ADDENDUM NO. 2

Date: November 16, 2021

**Hobbs Middle School HVAC Replacement
Shelley School District No. 60
Shelley, Idaho**

A1.2

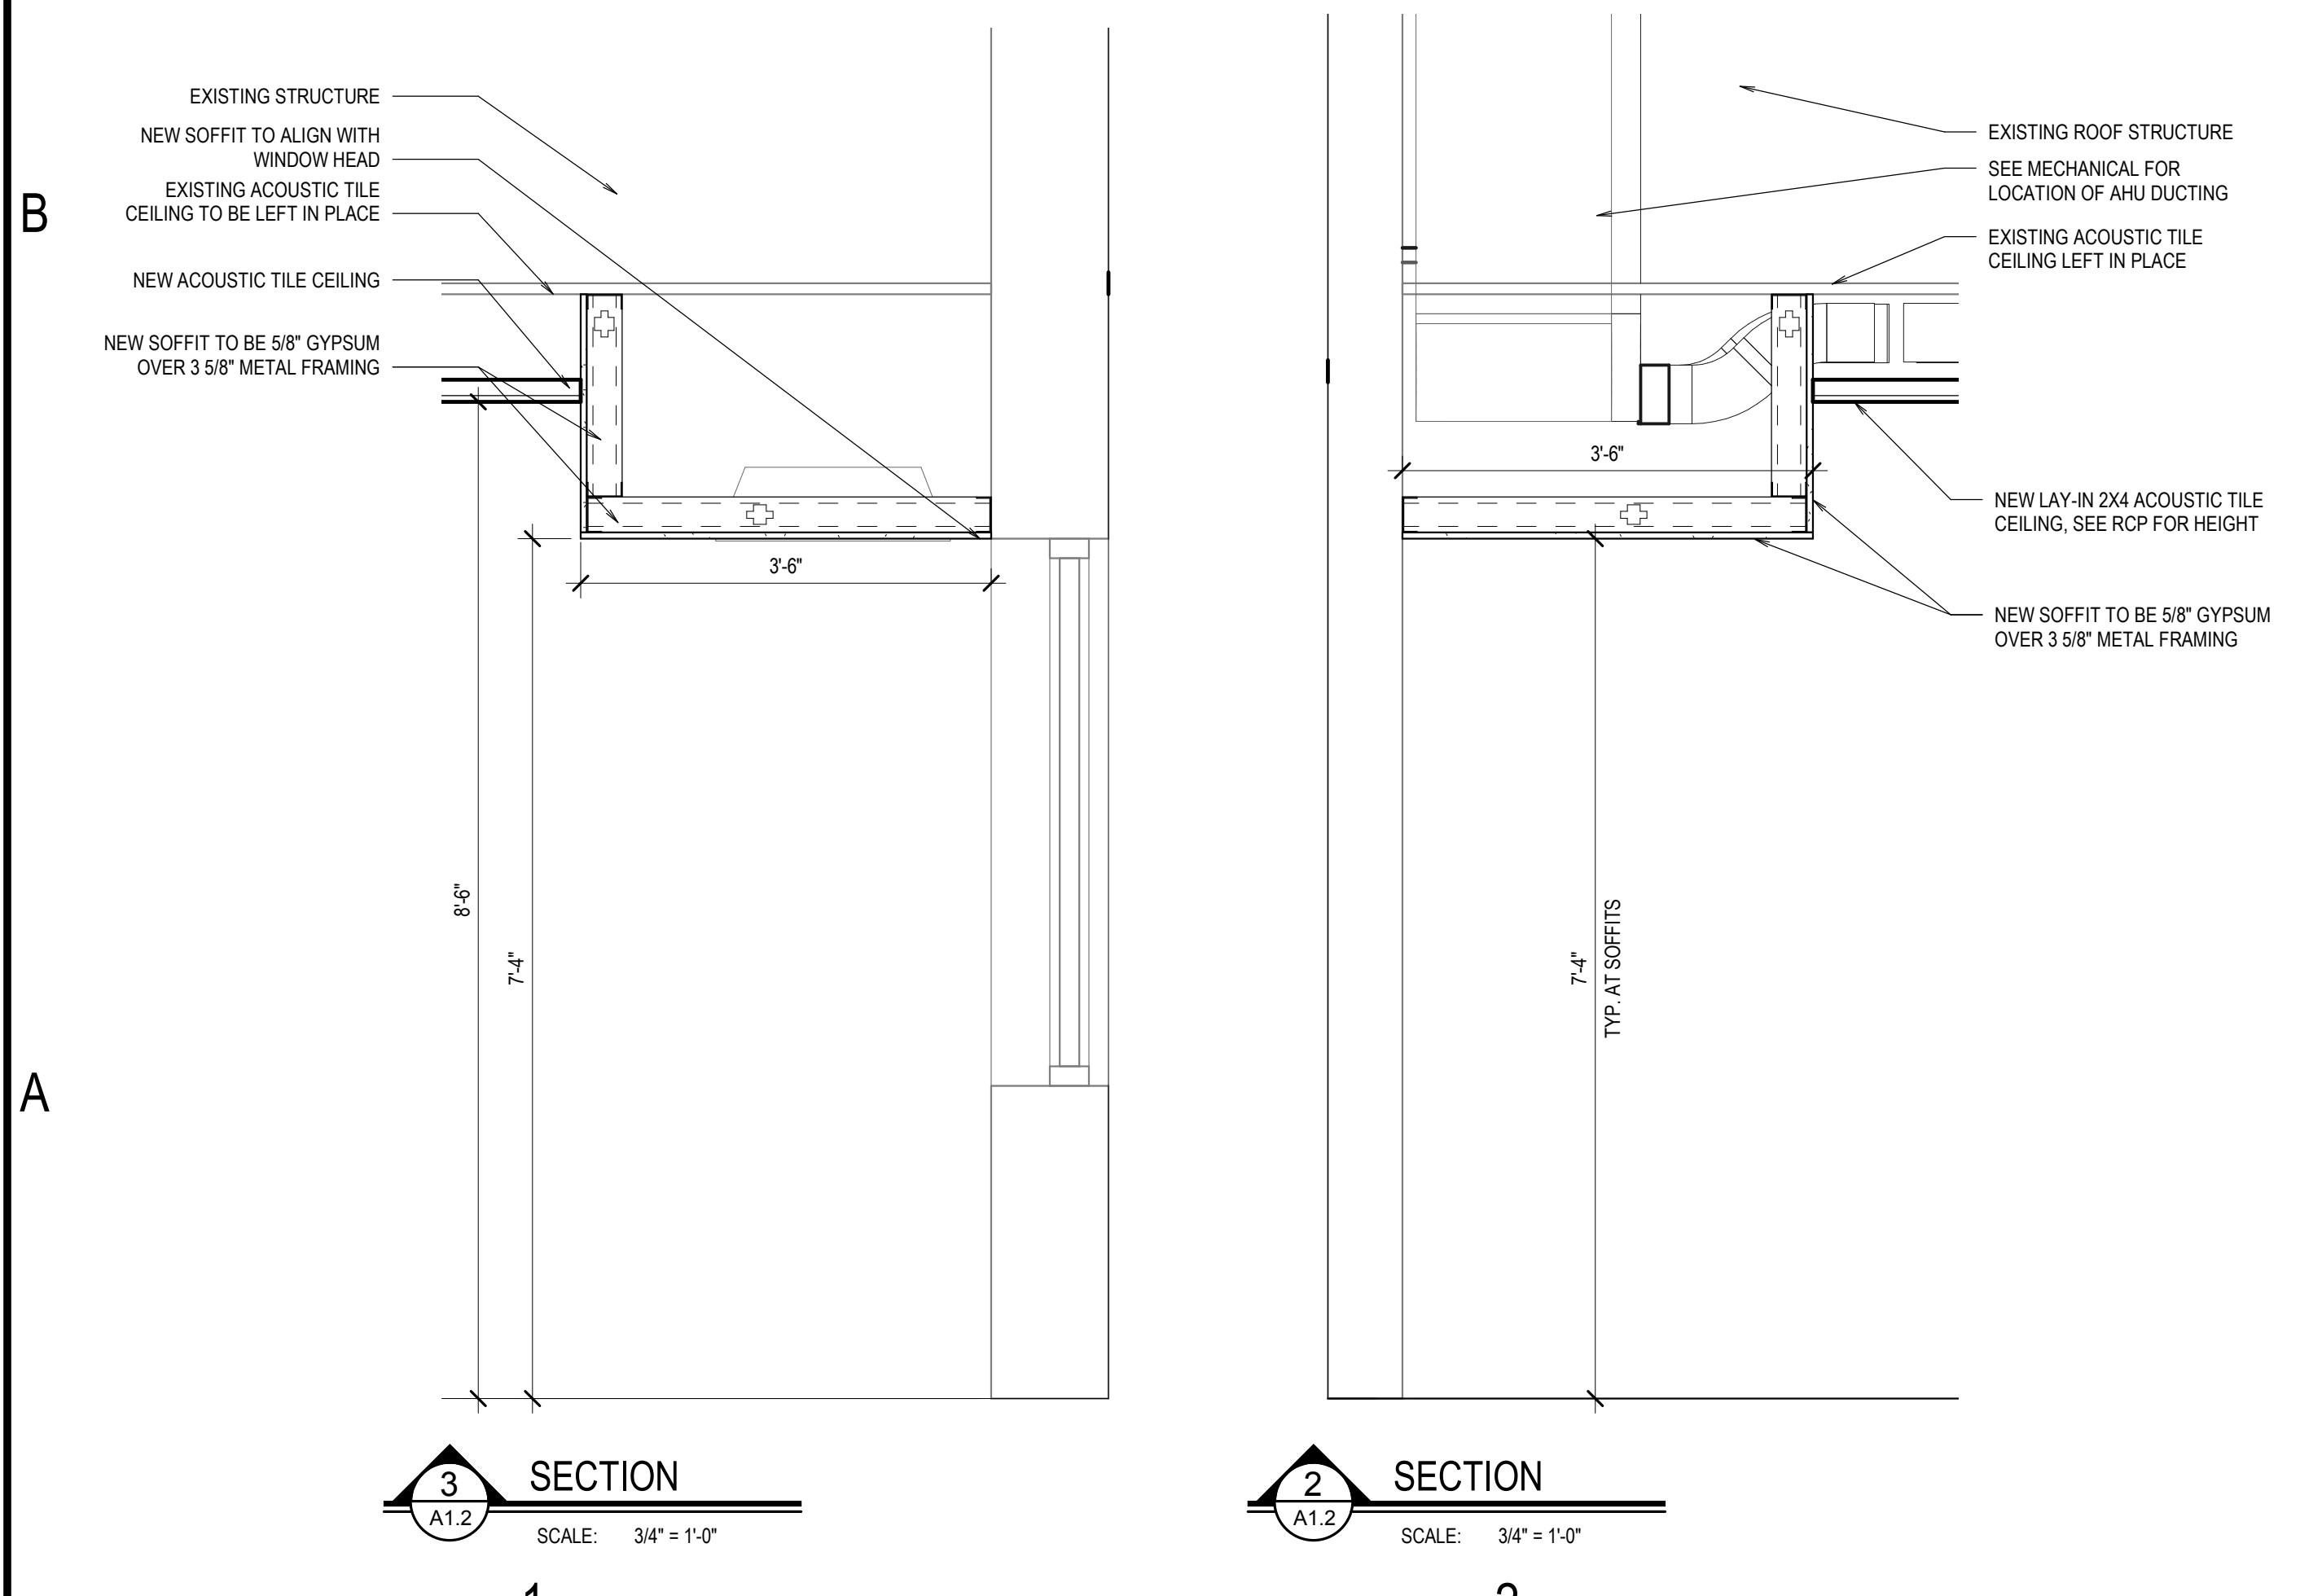
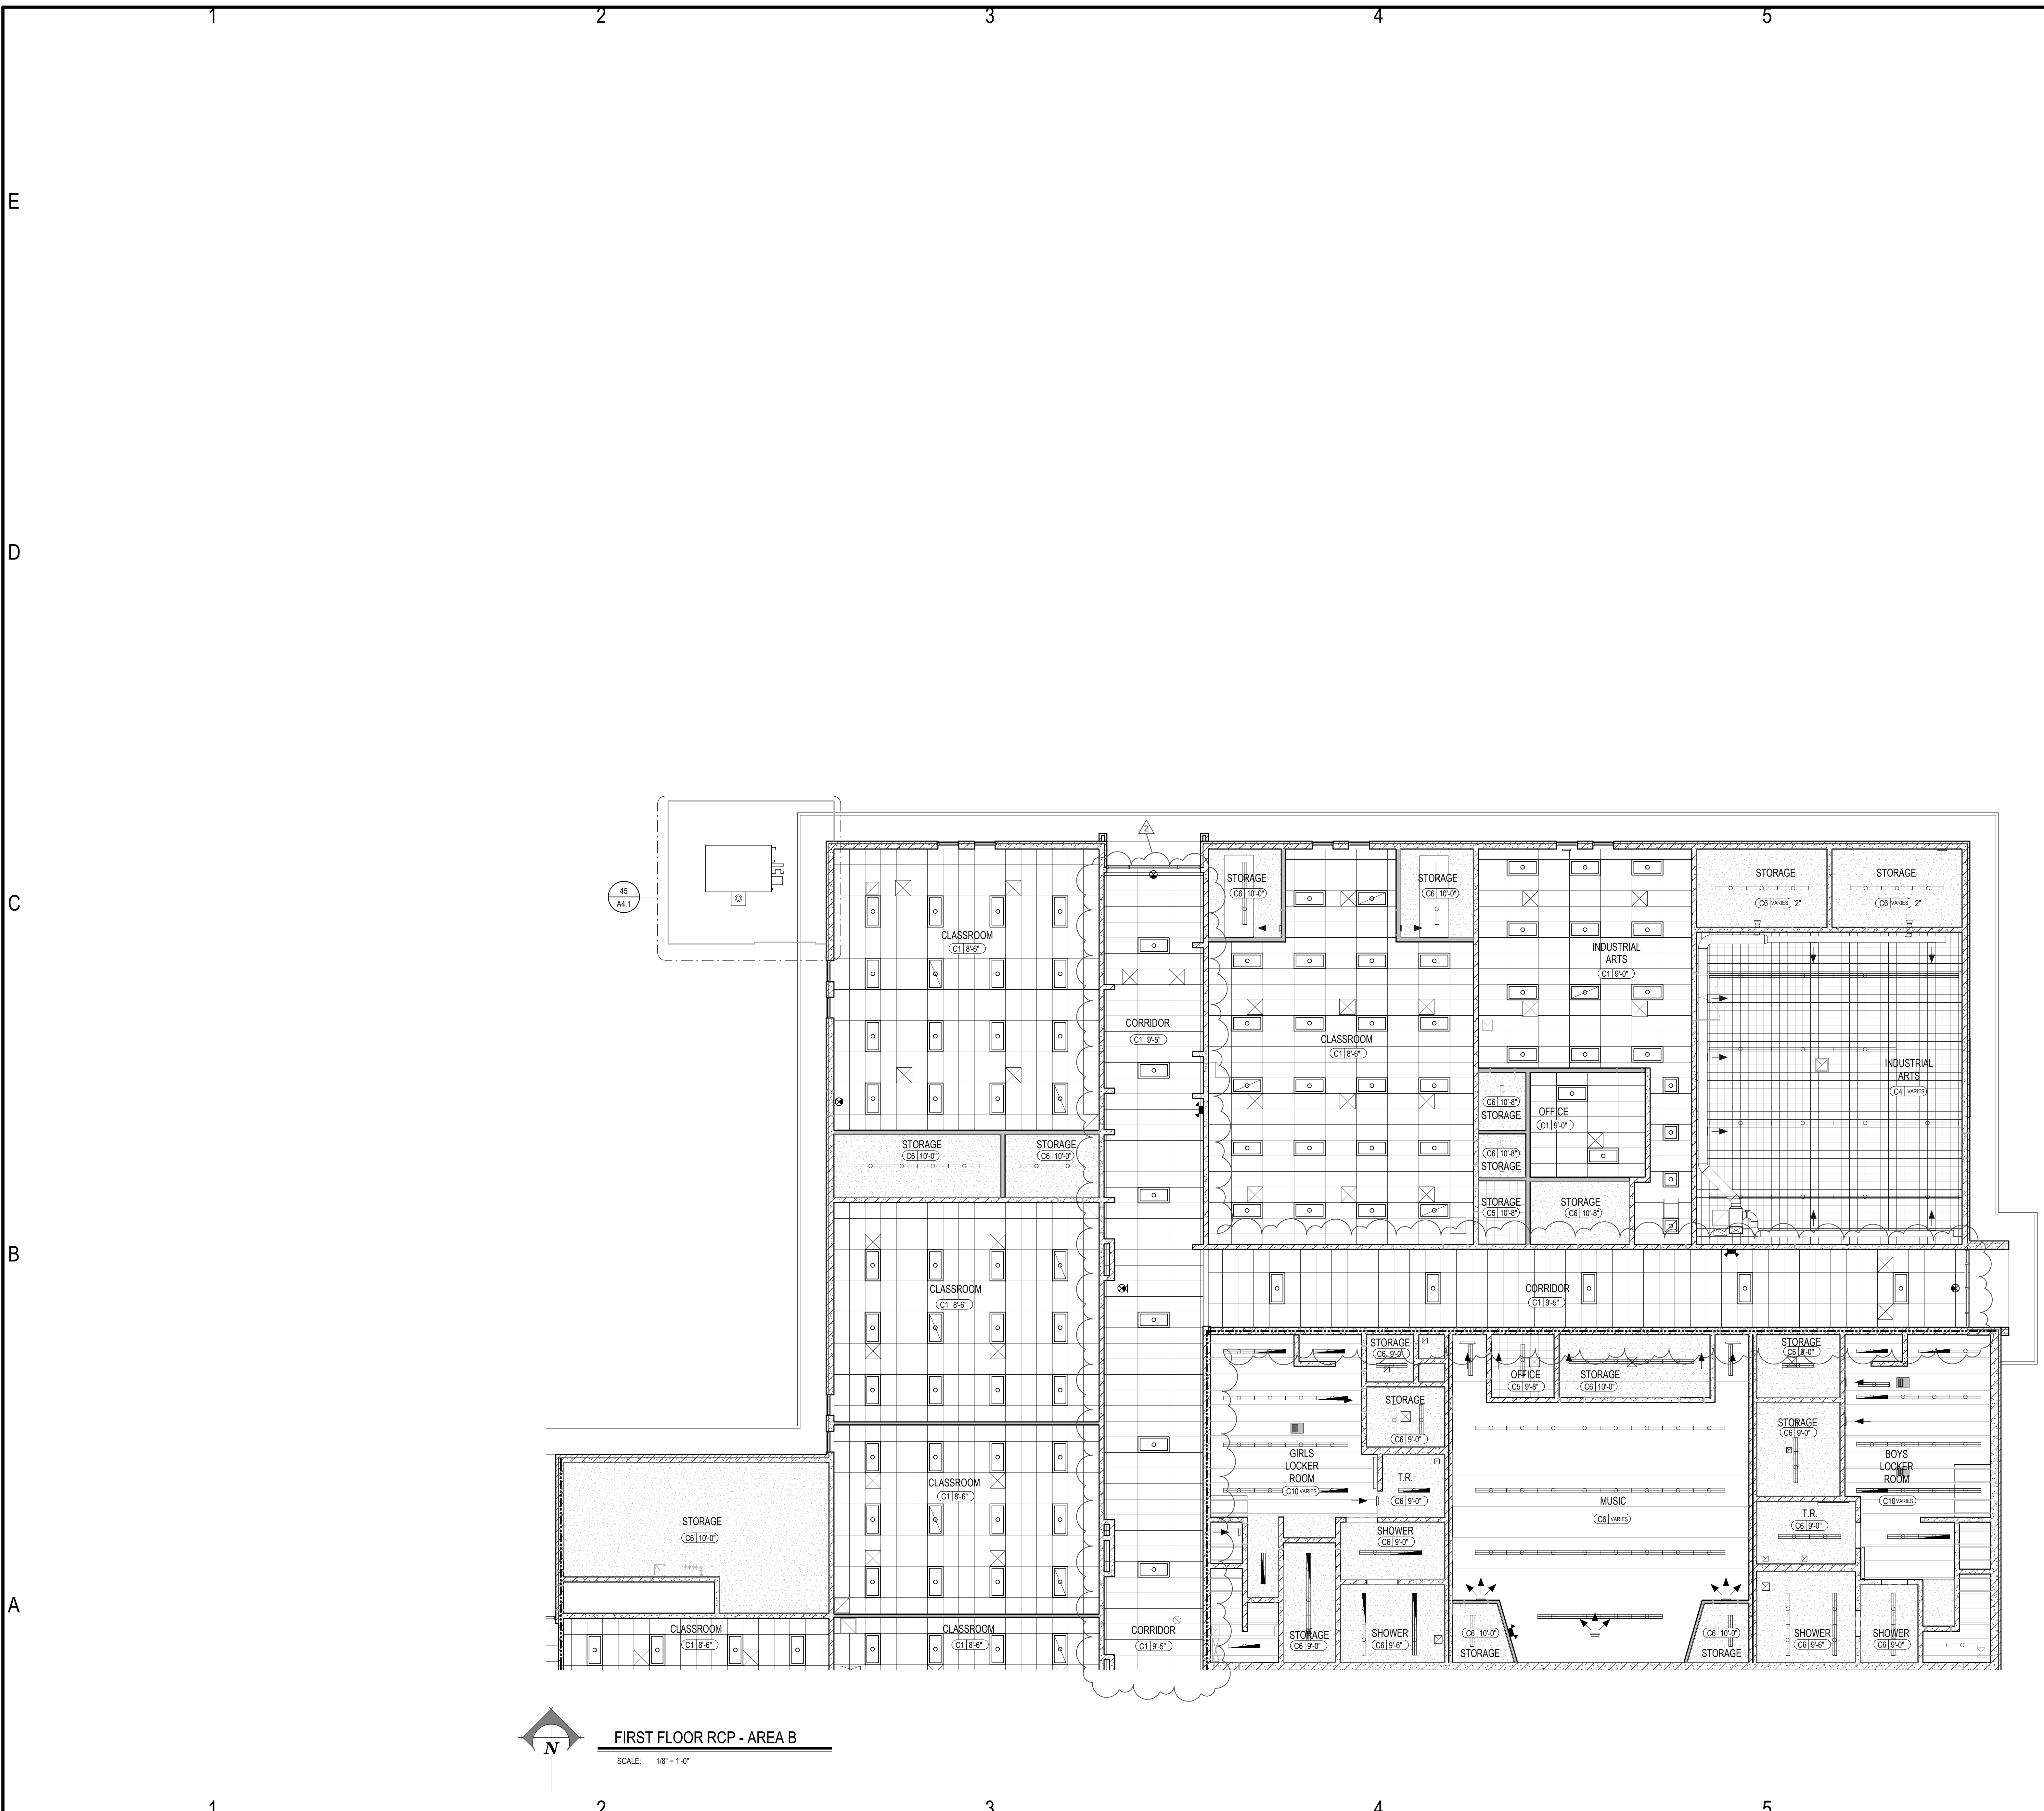
1. Add Alternate #1 to be deleted. Scope of work from add alternate #1 now to be included in the base bid. That work consists of demolishing and removing the existing corridor ceilings and installing new ceilings per the revised addendum drawings. Also included are rotating the corridor lights, so all corridor lighting is perpendicular to the flow of traffic. See revised sheets A1.0-A1.4. for corridor lighting orientation and location. Sheet A2.2 to be removed from the bid set.
2. No bids will be accepted by fax or email.
3. Existing floors to remain.
4. School district will remove and reinstall all furniture as needed.

1. See revised Sheet A1.0-A1.4
 - a. Refer to clouded changes in the attached sheets.
